OUR REF.NO. 061

M645 SUPER

3 ROLL FILM HOLDER

7 TECHNICAL BULLETIN

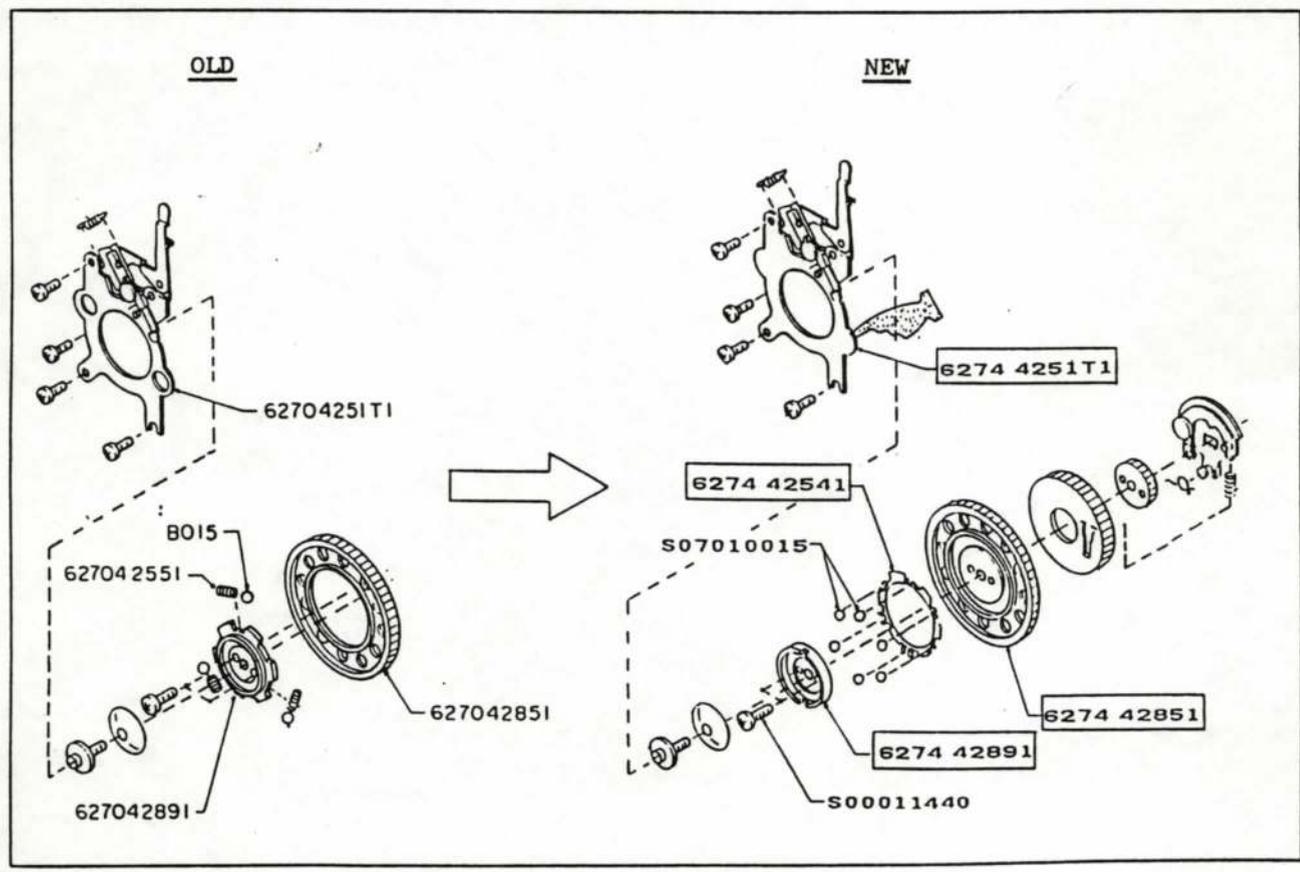
As informed you of the dropping out of steel ball(B01.5) for M645Super RFH with technical bulletin OUR REF.NO 057 of 25, DEC, 1987, Modify the winding mechanism to that of type 135 RFH.

<u>Disuse</u>		<u>Newly add.</u>
6270 4251T1	➔	6274 4251T1
6270 42891		6274 42891
6270 42851		6274 42851
6270 42551		6274 42541
BO 1.5 x 3pce		S07010015(BO 1.5) x 6pce

By modification No. "06" on backside of the Back lid for RFH.

New Film roller and film guide plate

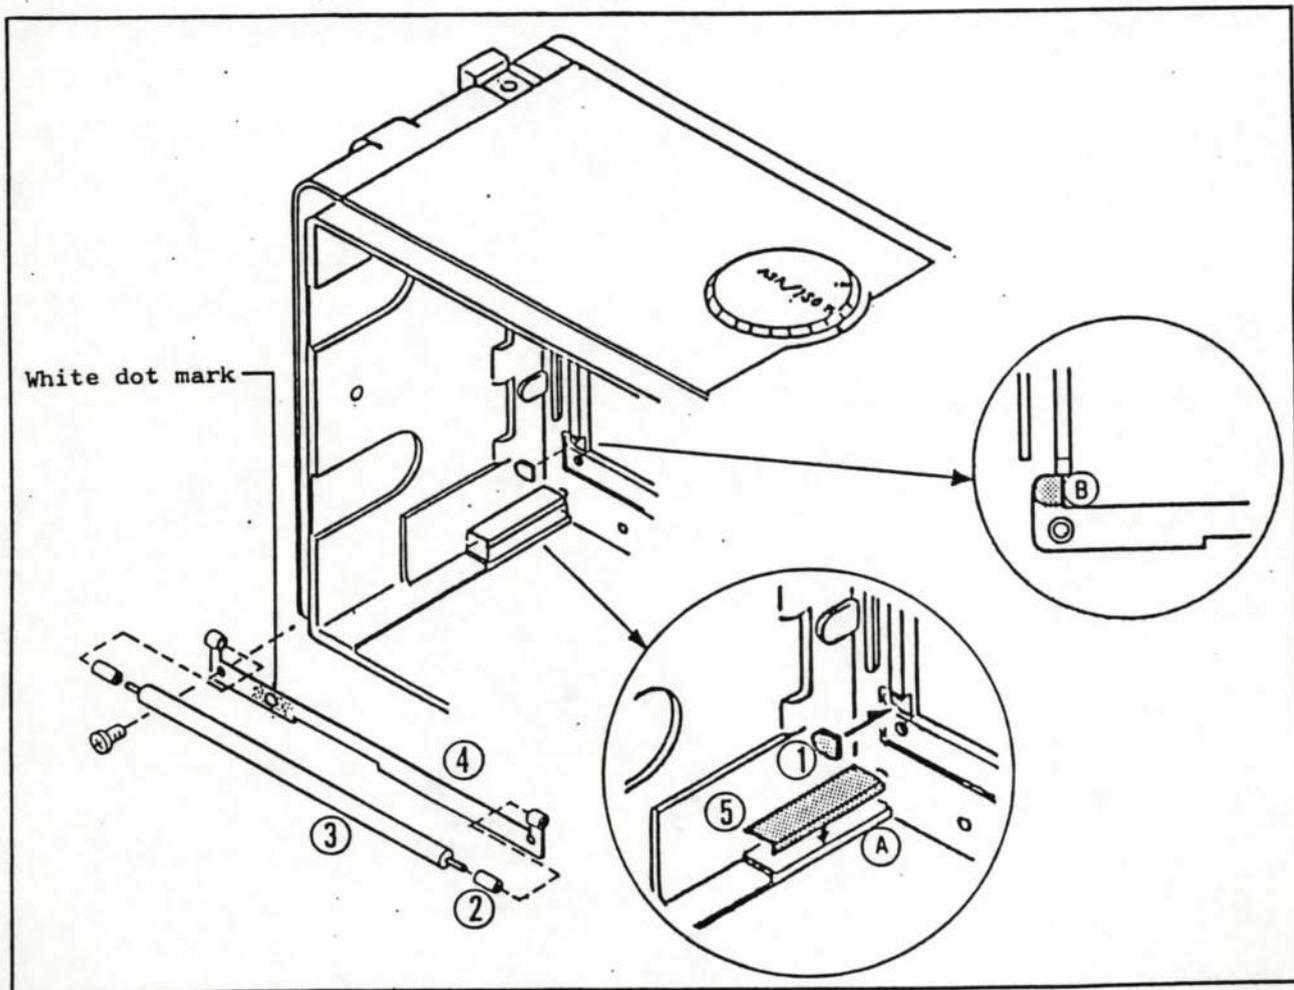
To make more smooth and light film winding two film rollers and two film guide plates should be provided for the improvement.

Note: This improvement will be very effective for film transport problem and film scratch on T-Max 120 film.

- 1) Remove two film rollers and leaf spring of the roller.
- 2) Stick 6270 41391 washer into four cavities under brackets of the leaf spring with some adhesive (See B).
- 3) Set 2 new collar to both sides of 3 new roller and then set the roller into 4 leaf spring.
- 4) Install the leaf spring with roller to RFH with screws.
- 5) Stick 6270 41561 new film guide plate with some adhesive (pattex) on the place A additionally.

- * It is not necessary to remove the former film guide plate.
The new film guide plate must put on the former film guide plate.

Note: * Diameter of new roller is 2.0mm, but present roller is in 2.5mm.

- * New film guide plate is in metal and its thickness is 1.5mm.
Conventional film guide plate is in plastic with its thickness 1.5mm.

By modification No. "04" on backside of the Back lid for RFH.

Fill the hole with 6270 42571 Cap	1/1	87	8
-----------------------------------	-----	----	---

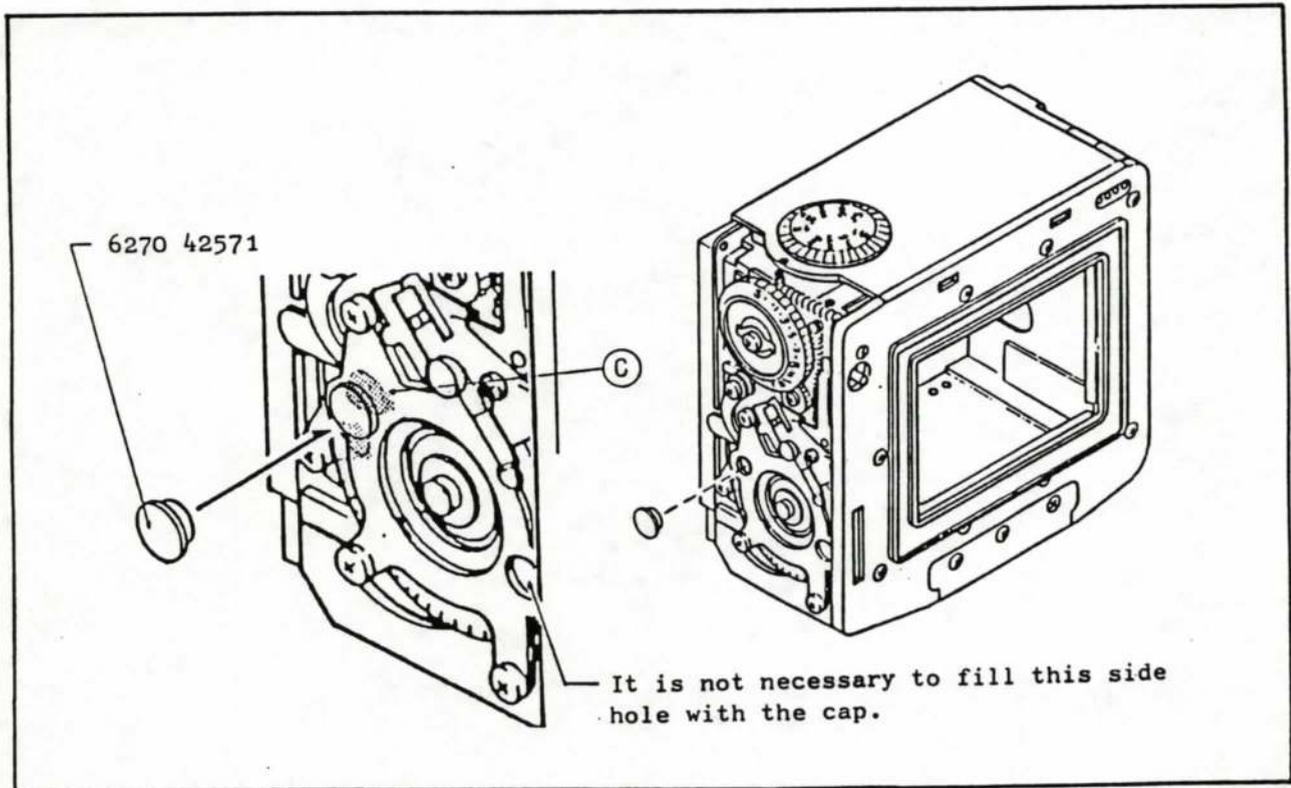
To prevent unexpected dropping out of B01.5 steel ball, the hole should be filled as follows :

- 1) Put 6270 42571 cap on the hole pointed with an arrow.
- 2) Sparingly apply a bit of adhesive (pattex) to the cap as shown in the drawing (C) .

Note : Don't put the cap on the other side hole.

By modification No. "04" on backside of the Back lid for ~~RF~~.
RFH

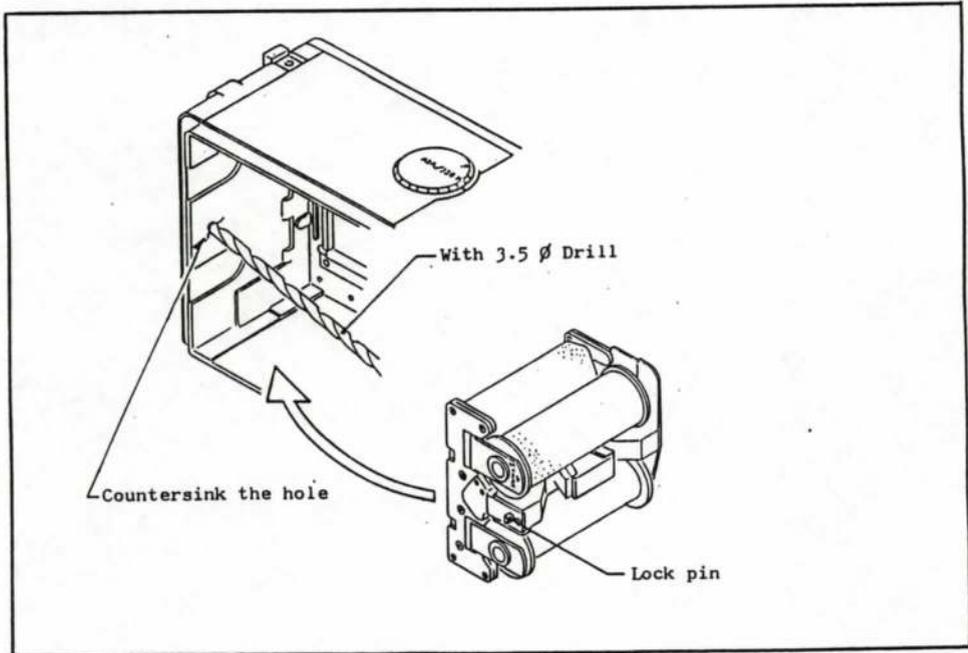
Phenomenon : When film insert is set into film roll holder, sometimes the lock pins of film insert will not be locked into the Hole of roll film holder certainly.

Step : Slightly countersink the hole of film roll holder shown in the drawing with 3.5 ϕ drill.

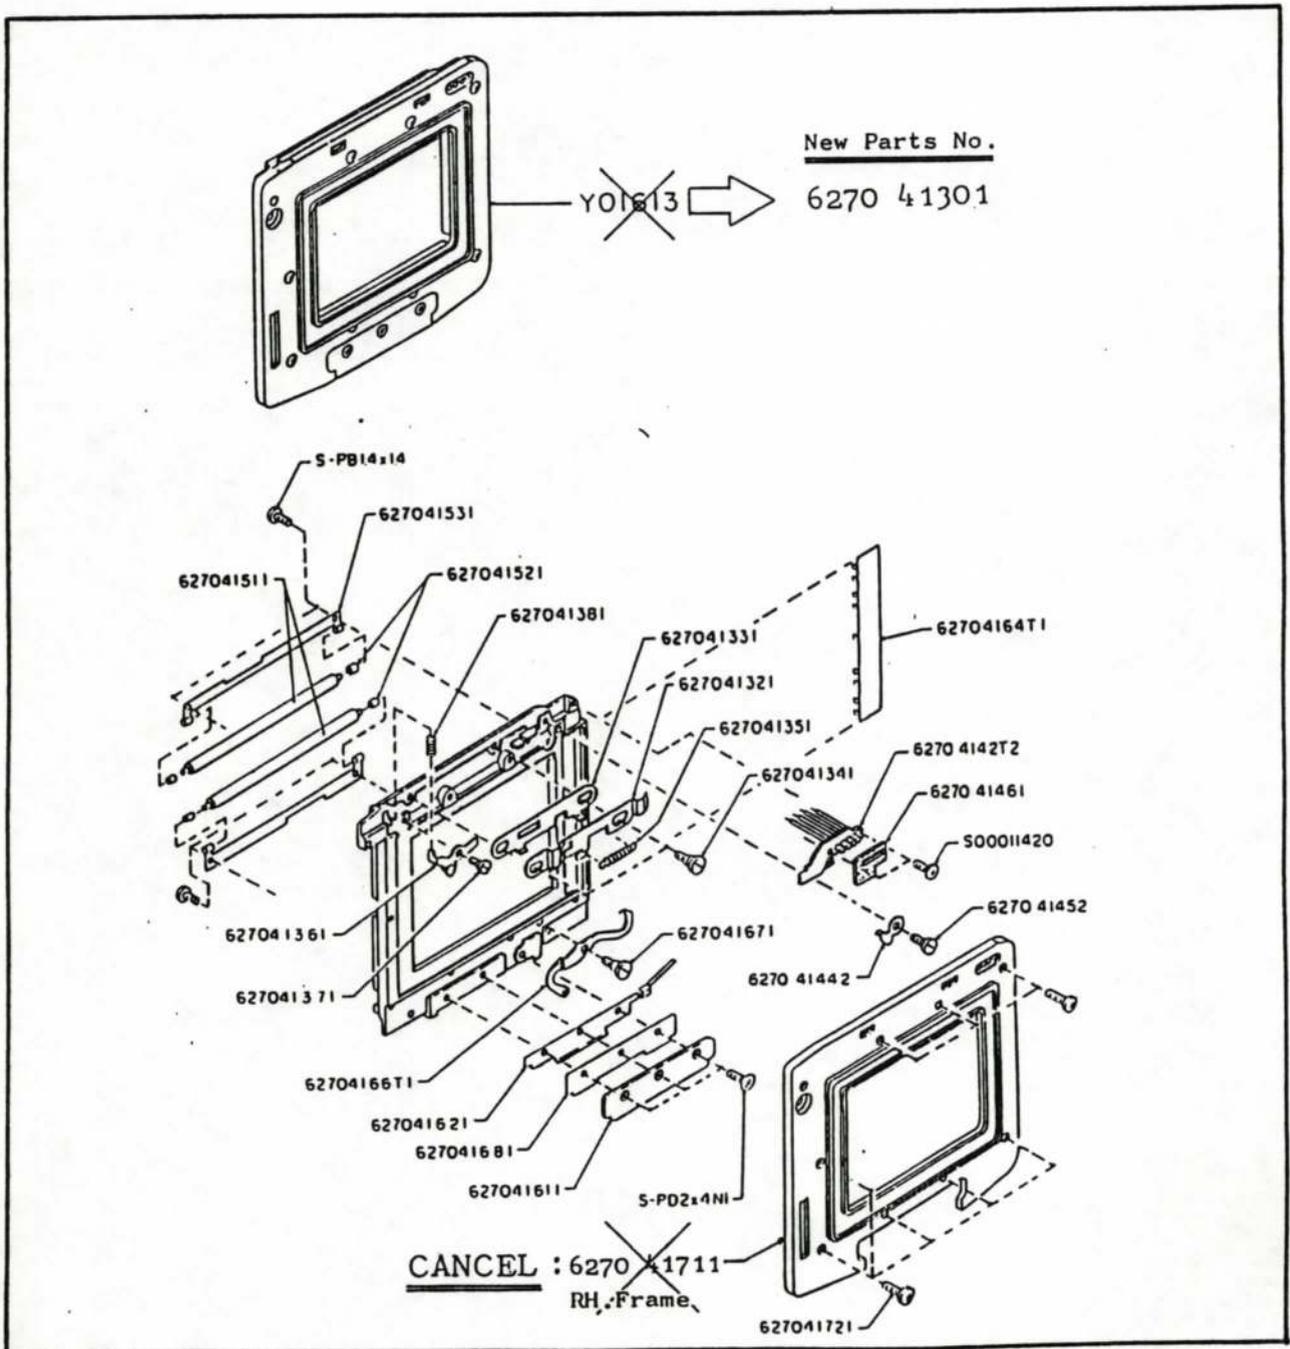
Will be not supplied P/NO 6270 41711 : RH Frame.

F.Holder to preserve accuracy of the flange back and film rail surface flatness, so that replacement of RH.frame is assembled into F.Holder body.

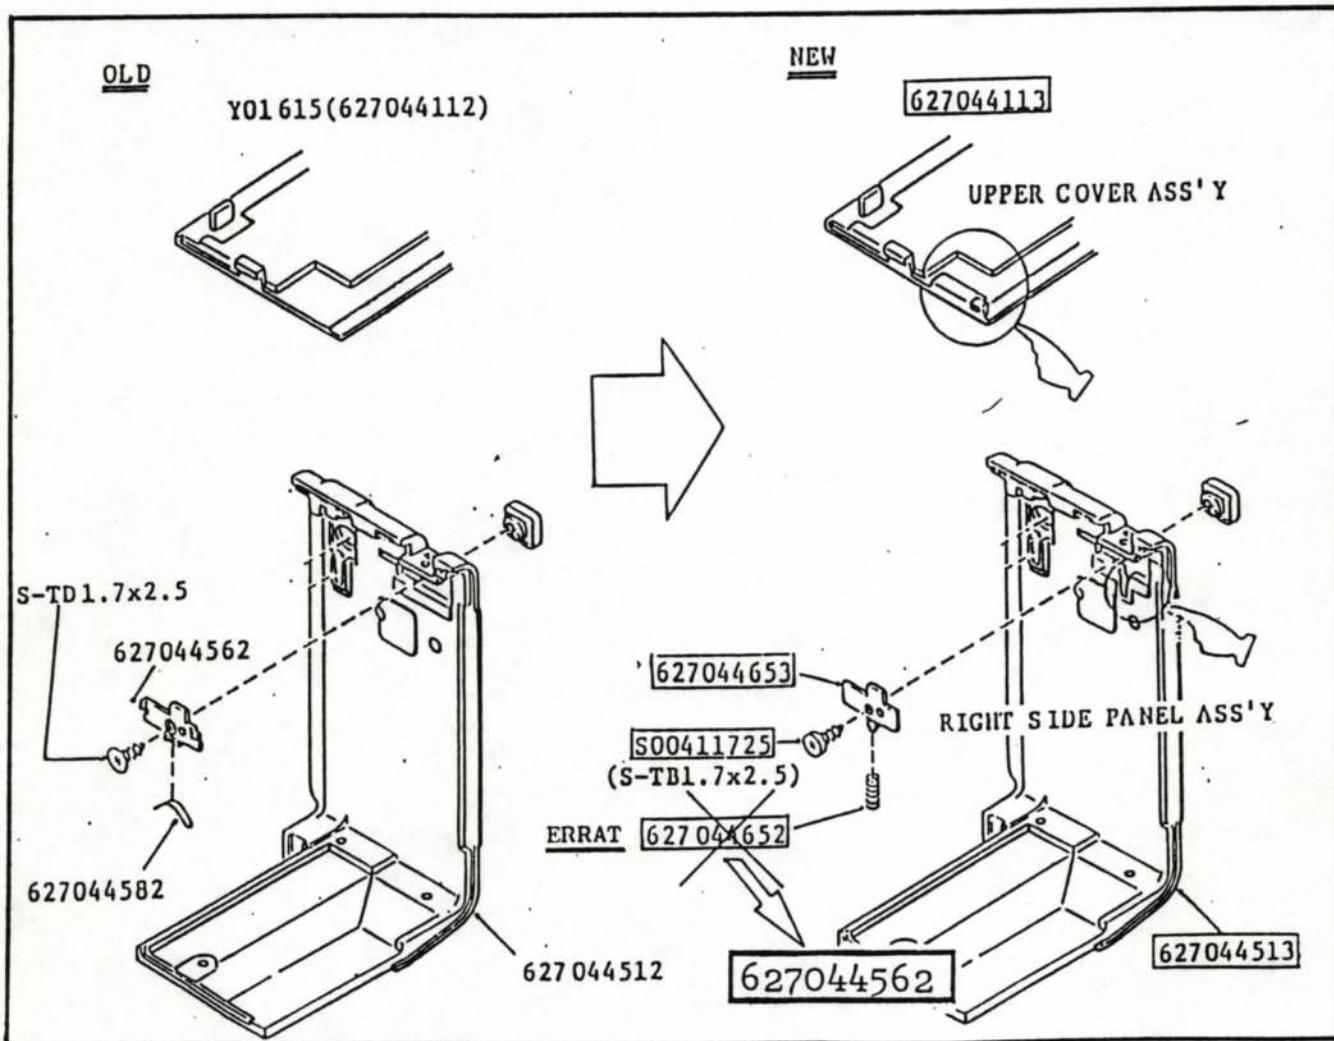
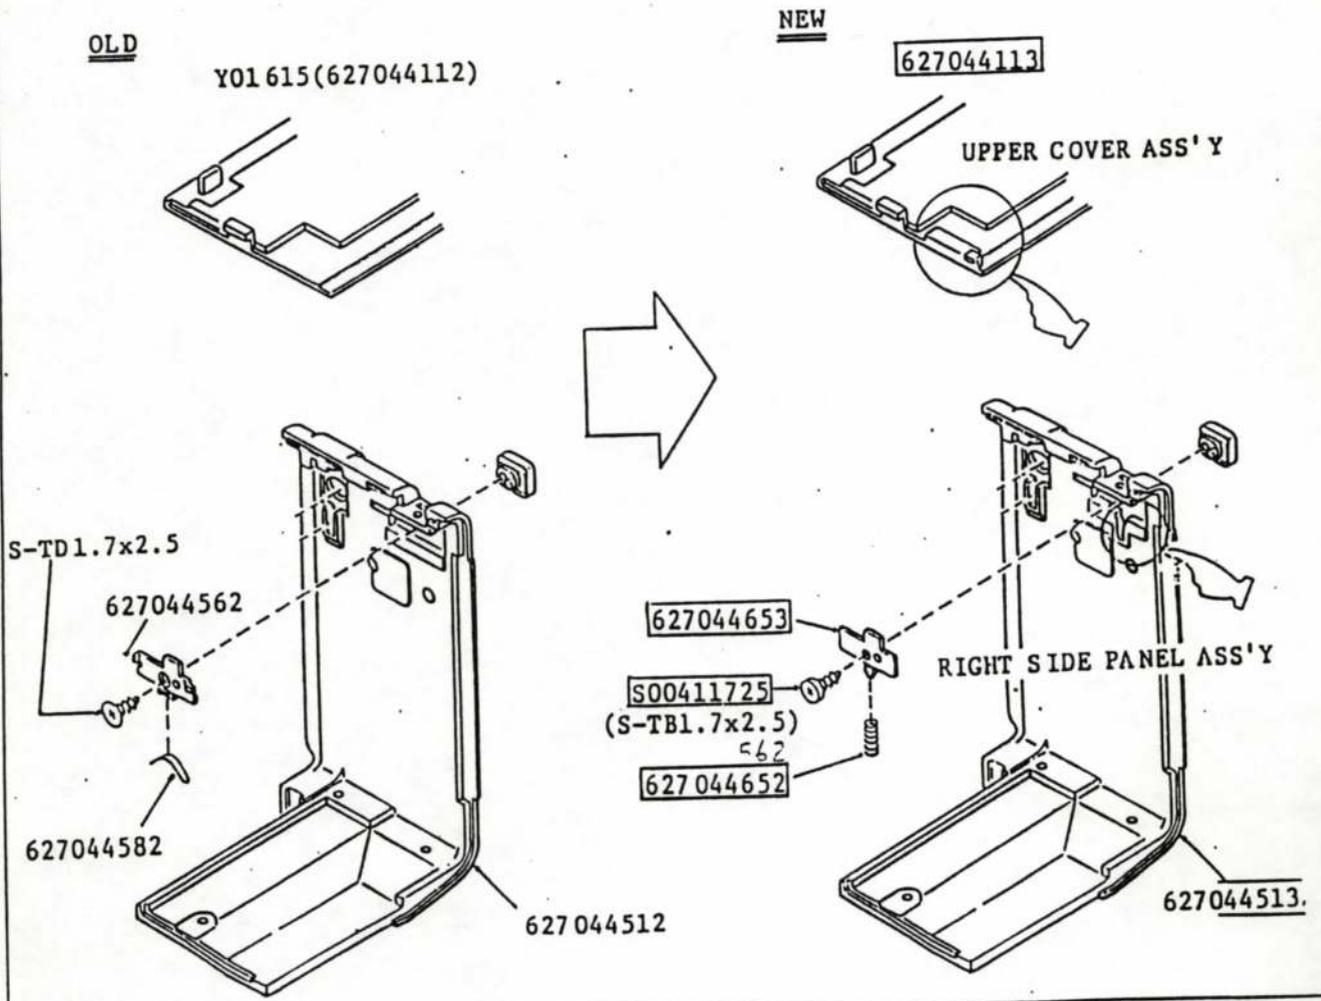
1. PURPOSE : Improvement of lock release system.

2. REPLACEMENT OLD & NEW PARTS

: New upper cover and new side panel must be in set:

: Compatibility of new and old.....None

3. MODIFICATION DATE : From September, 1986.

ERRATUM	AMEND TO READ
627044652	→ 627044562

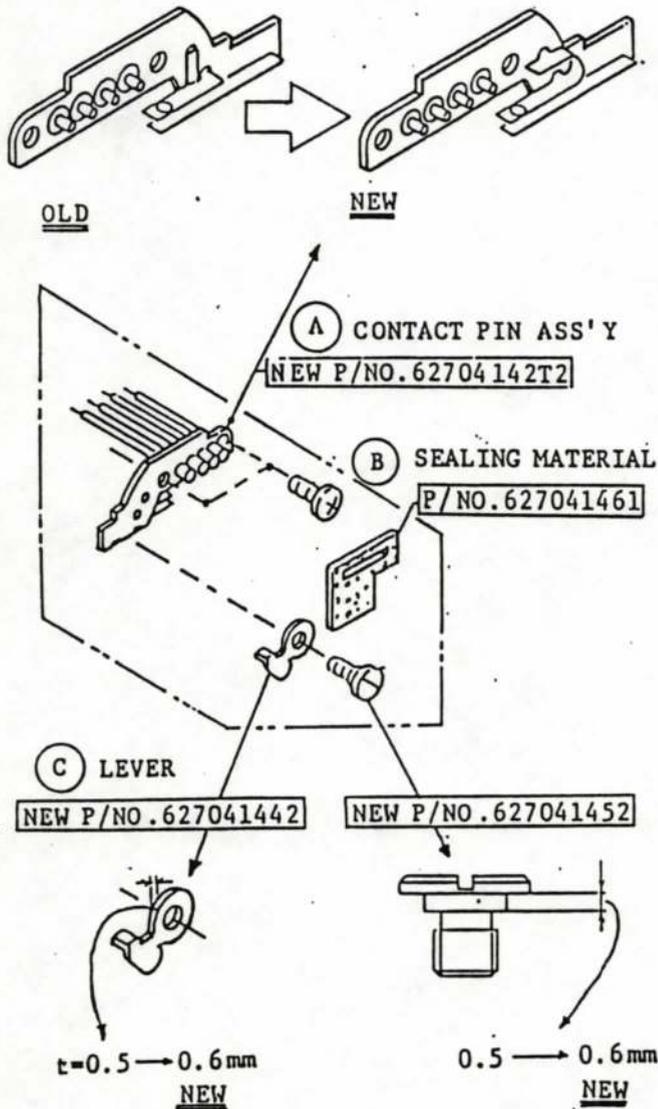
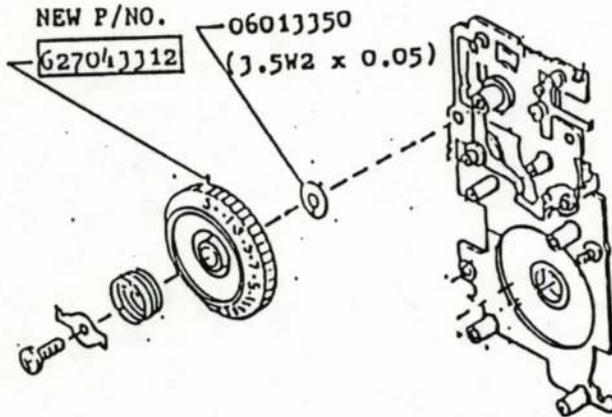
1. CAUSE

- 1) Contact of contact pin ass'y :Weakened
- 2) Light leak from space of contact pins.

2. MODIFICATION

- 1) Shape of contact.
- 2) Addition of B Sealing material.
- 3) Shape of C lever and it's screw.

: From February, 1986.

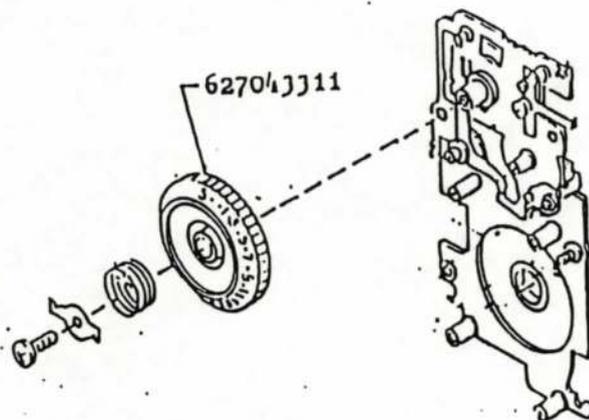
1. CAUSE

: Gear teeth of the E-Counter Disk are Broken.

2. MODIFICATION

: Material of E-Counter Disk : CHANGED. (Special hard material)

: Apply a Washer.

: Replacement of E-Counter Disk and Putting of the Washer.

NEW P/NO.627043312 E-COUNTER DISK.
P/NO.06013350(3.5W2x0.05) WASHER.

5. HOW TO DISCRIMINATE BETWEEN OLD AND NEW

: NEW.....Black MAT Color.

: OLD.....Black LUSTER Color.
